Re: Lower Santa Fe and Ichitucknee Rivers MFL Draft Regulatory Strategy

# Memo

Project: MFL Assessment using NFSEG

Subject: Evaluation of MFLs and comments regarding proposed changes to the LSFIR MFL

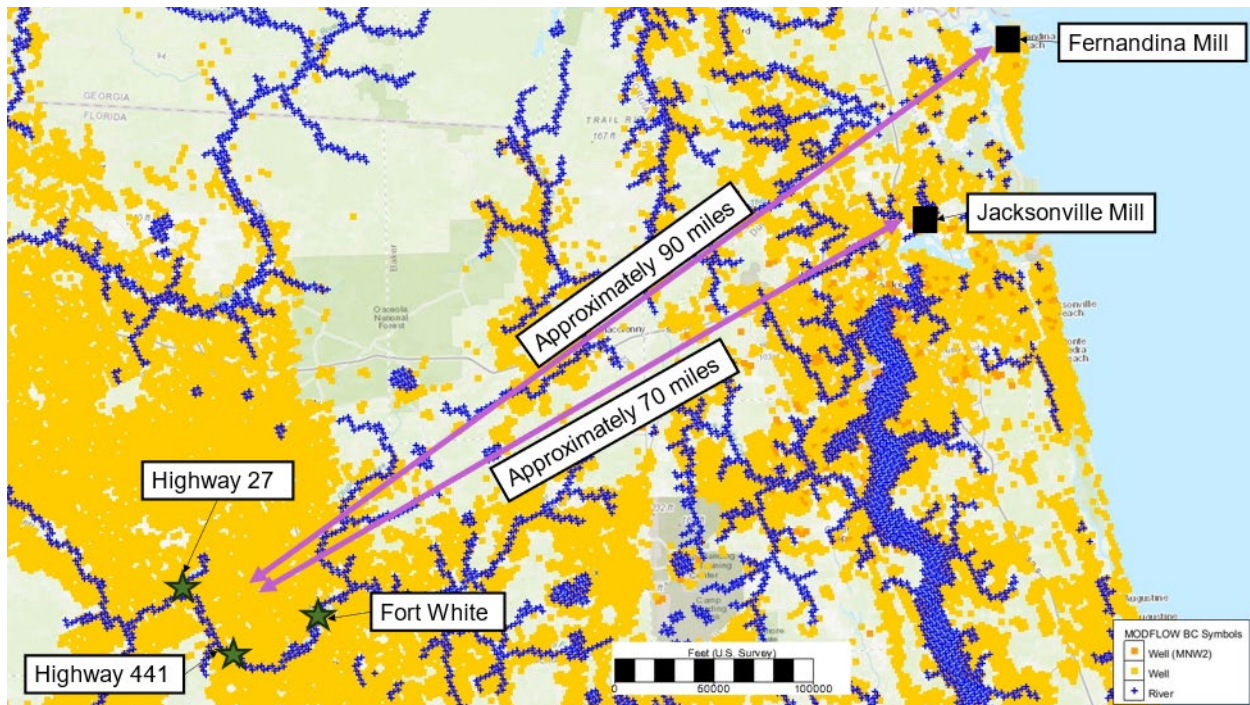
**Comment 2:** The proposed MFL rule assigns the same requirements to all modeled facilities regardless of the distance to the measured MFL. The farther away from the target MFLs, the greater the effect of the modeling error and uncertainty in the model. For example, small and seemingly insignificant differences in parameters such as recharge and river conductance could result in an important effect over a large distance. In other words, the farther a facility is from the measured MFL, the greater the uncertainty in the modeling results. The Jacksonville Mill is 365,250 feet (69 miles) and Fernandina Beach Mill is 480,000 feet (90 miles) from the three target MFLs, so the effect of any errors in the model would be greater on the Jacksonville and Fernandina Beach Mills than facilities closer to the MFLs since the errors get compounded by distance. Given the NFSEG simulated baseflow for the two timesteps have average residuals of 79.8 cfs and 135.4 cfs, the distance between the MFL and facilities must be considered.

**Figure 2. Location of Fernandina Beach Mill wells in relation to boundary conditions representing the Atlantic Ocean (red diamonds for constant heads), blue crosses for river boundary and green squares for drains.**

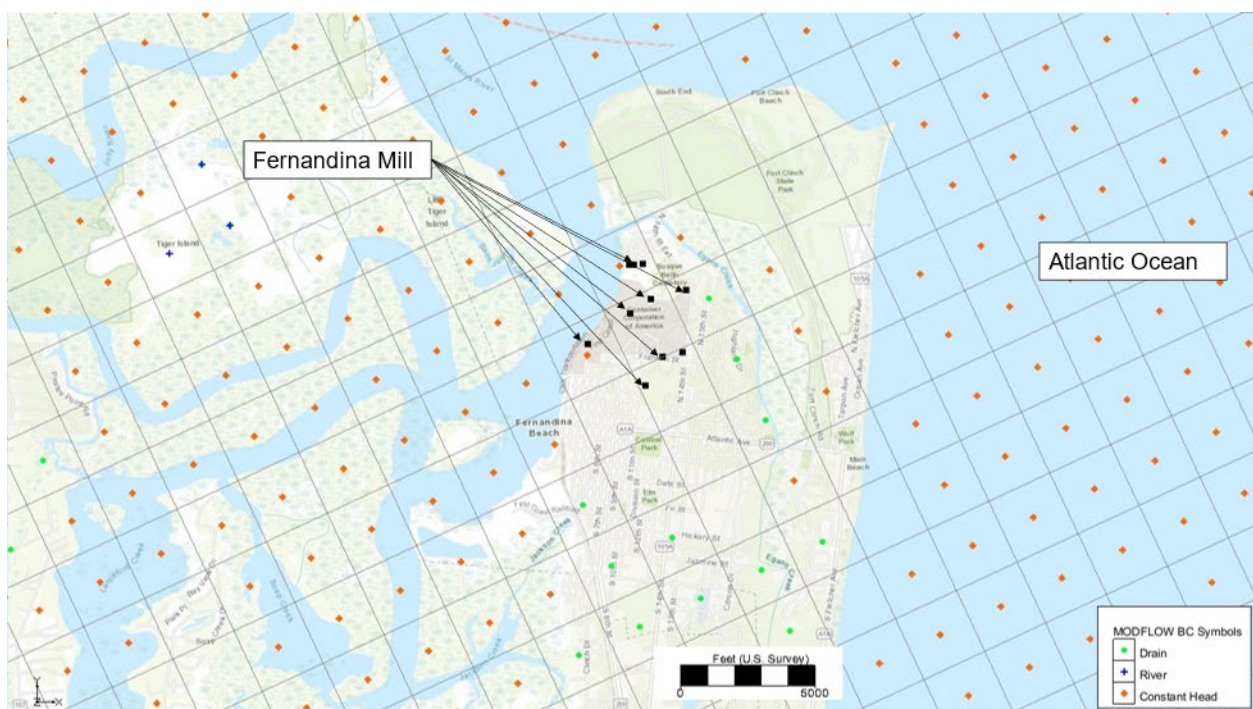
Comment 5: The Fernandina Beach mill is located on Fernandina Beach, right next to the Atlantic Ocean. It is east of the mouth of the Amelia River and just south of Egans Creek. The NFSEG model simulates the Atlantic Ocean, Amelia River and Egans Creek as a constant head boundary. In a constant head boundary, the head does not change. The water flows in and out

of the groundwater model at a flux sufficient for keeping the head constant. Figure 2 shows the location of Fernandina Beach mill and its wells in comparison to all of the boundary conditions surrounding it. This figure shows all layers and all boundary conditions in each layer in each cell. As can be seen in Figure 2 the wells associated with Fernandina Beach mill are adjacent to, and in some cases in the same cell as, constant heads and drain cells. These boundary conditions control the effect of the simulated pumping in the model. Any changes to these boundary conditions, for instance, a decrease of conductance value in the drain cells or a slight increase by even a factor of .0001 ft in the assigned constant head cells elevation, could change the simulated drawdown cone of depression and simulated change of flow in simulated surface water bodies significantly. The 0.01 ft<sup>3</sup>/s MFL rule is using the model in a way that is outside of the models ability to accurately determine the effect of pumping occurring at Fernandina Beach mill on the LFSIR MFLs.
